Michael Manser Associates
 8 Hammersmith Broadway London W6 7AL 01-741 4381

contract
 38+40 ETON AVENUE
 LONDON NW3

drawing
 PROPOSED THIRD FLOOR+GALLERY PLANS

drawing
REAR ELEVATION PROPOSED

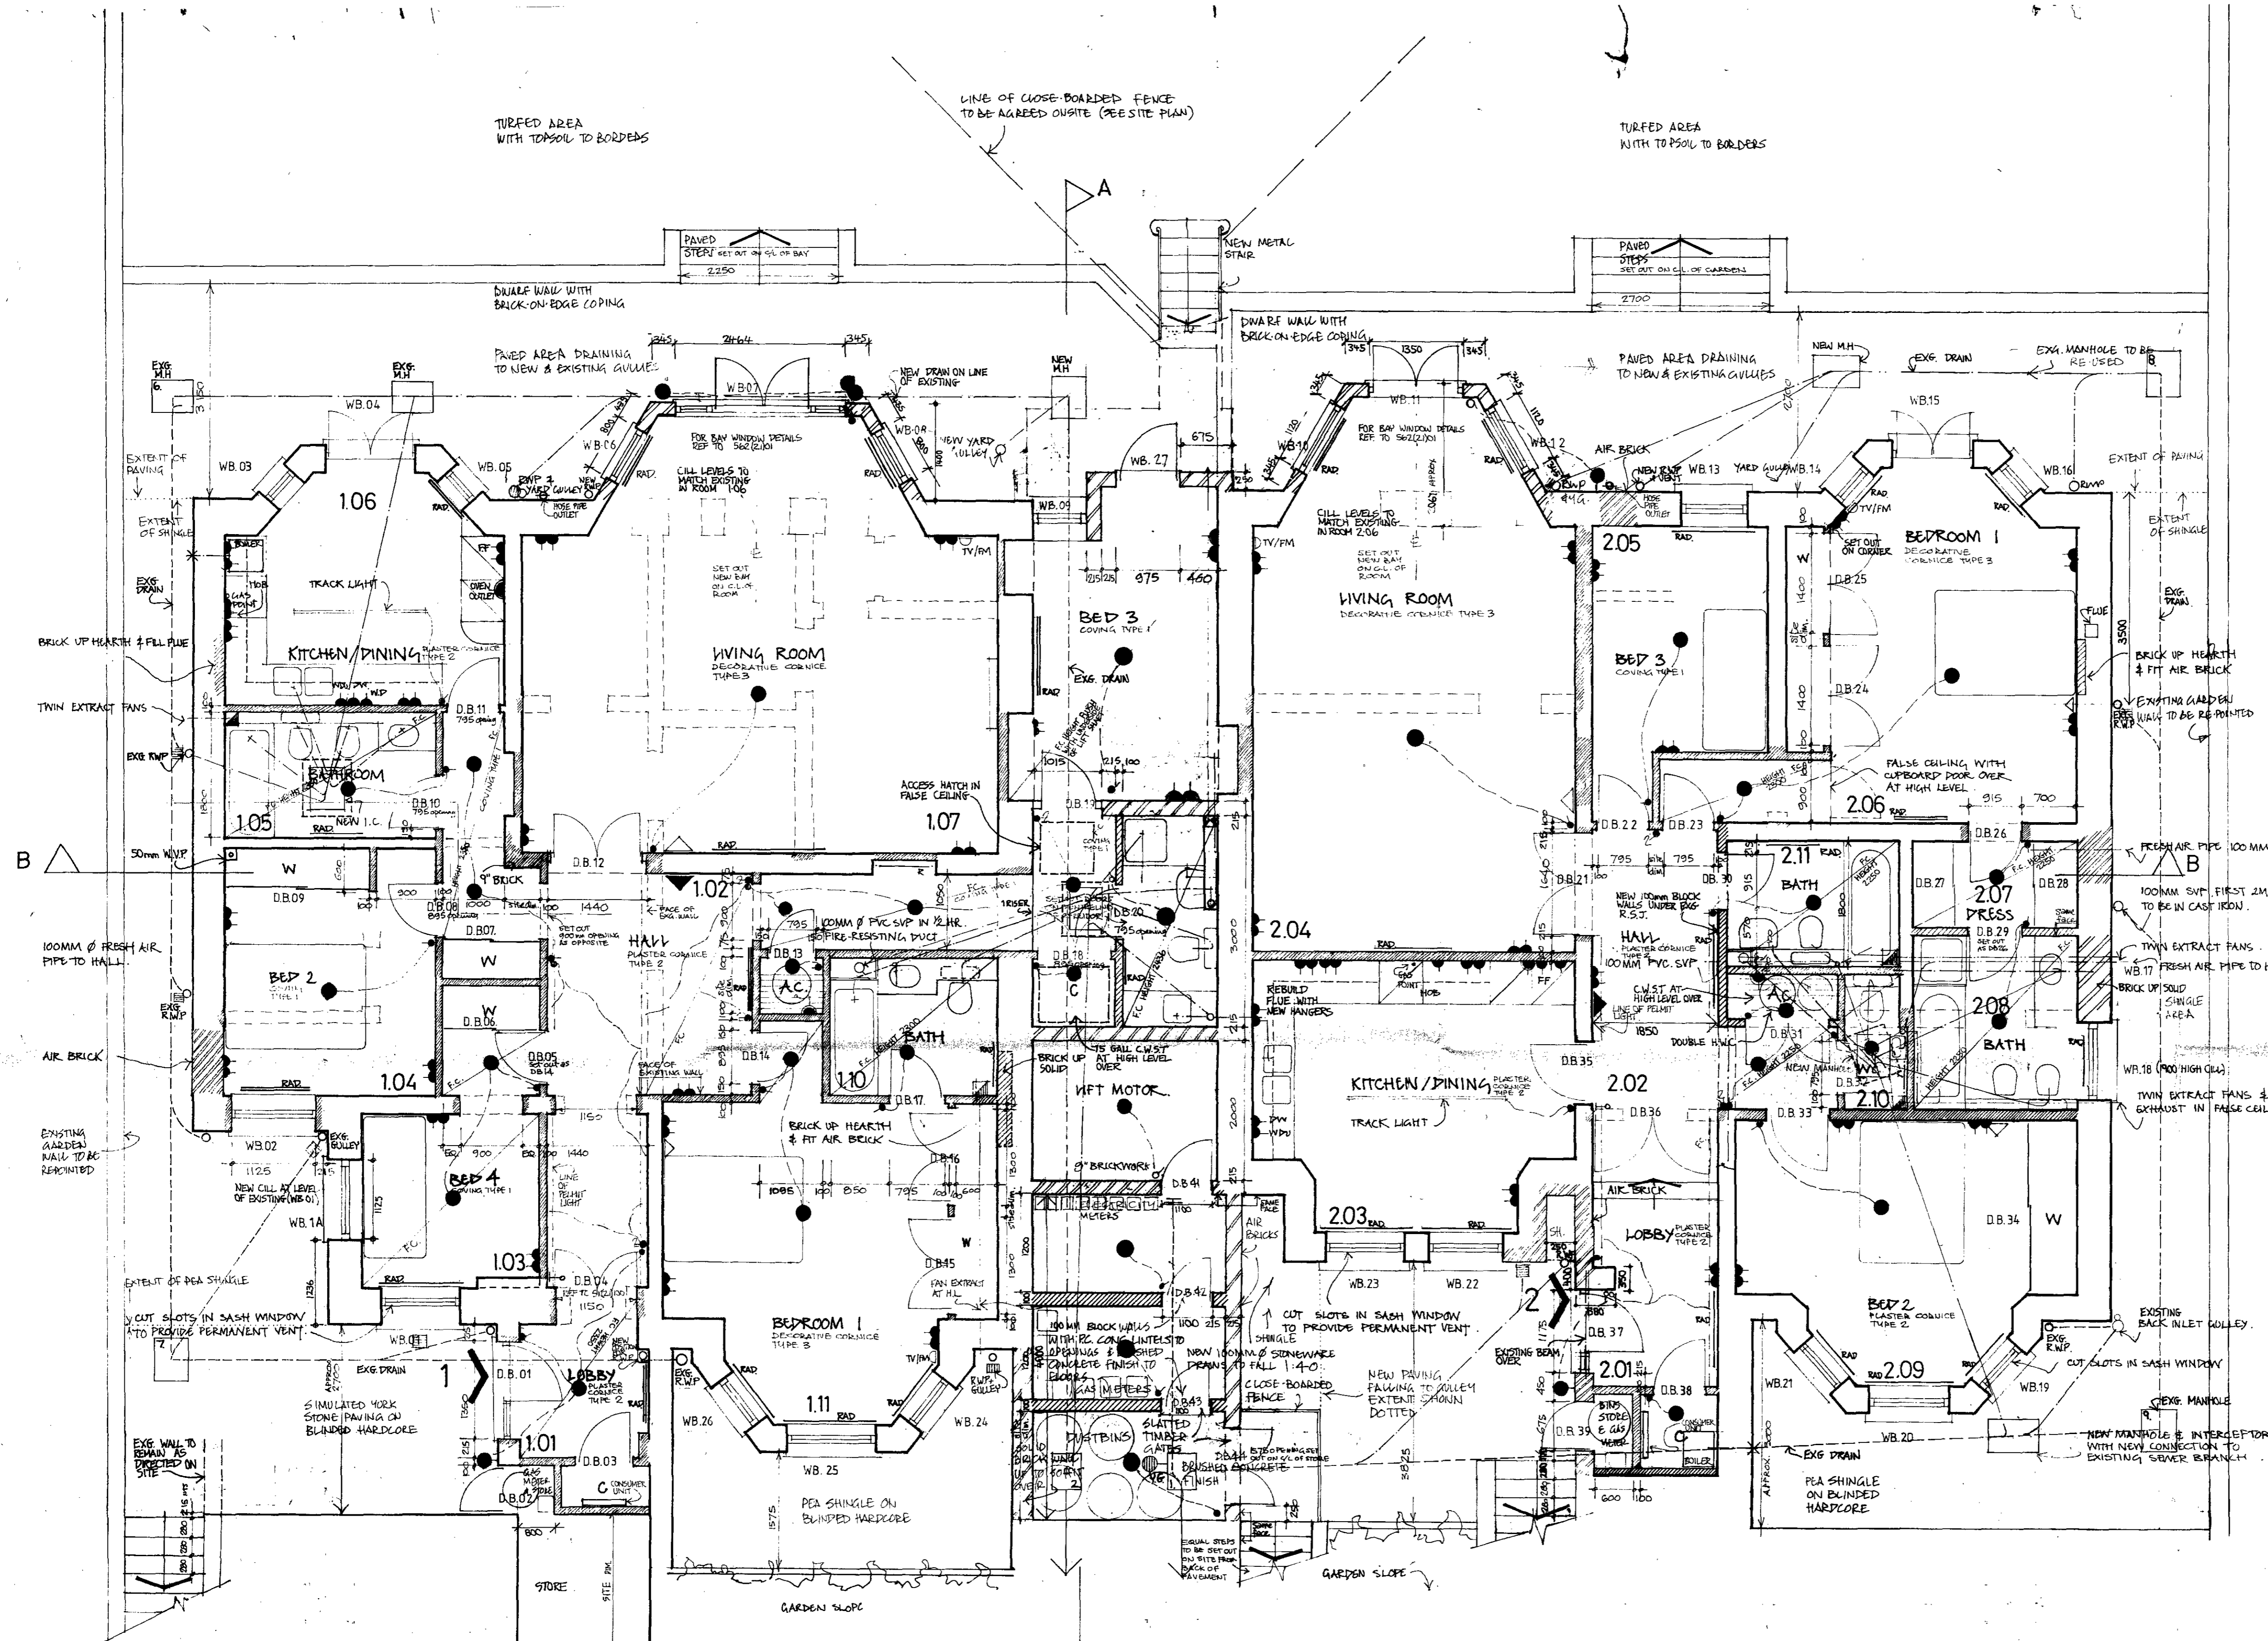
D. WINDOW TYPES, W/ CASEMENT OR SASH CORRECTED 26/1/85	
C. REAR ELEV. LINK BLOCK DESIGN 10/5/85	
B. REAR ELEV. LINK BLOCK DESIGN 10/5/85	
A. REAR ELEV. LINK BLOCK DESIGN 27/1/85
